Redfern Station Upgrade – New Southern Concourse

Response to Submissions

10-Sep-2020

Figure 6-2 Little Eveleigh Street indicative shadow diagram (with the Project)

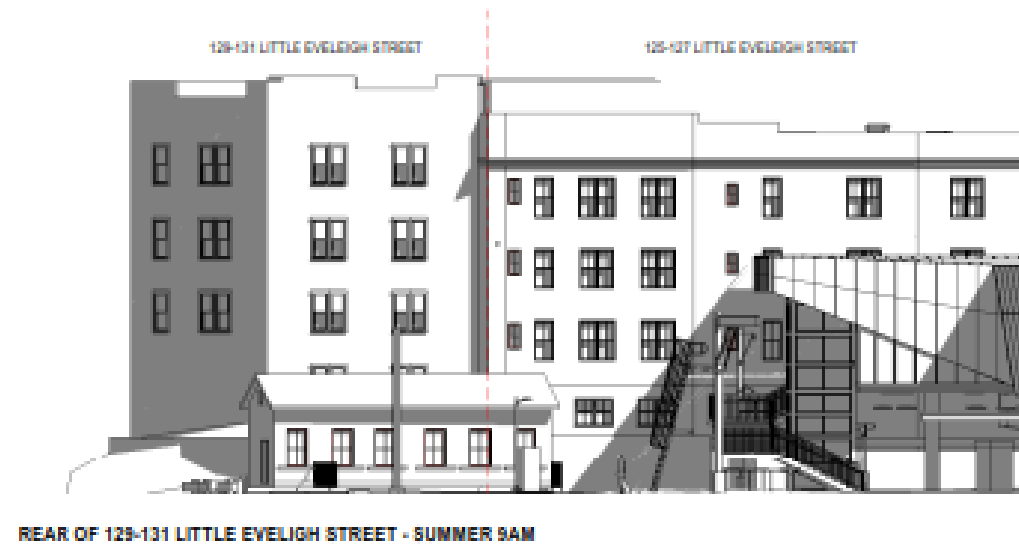
Figure 6-2 shows the proposed concourse providing limited shading to the rear of properties on Little Eveleigh Street. There are no new features which would cast new or larger shadows onto the street itself or surrounding property frontages.
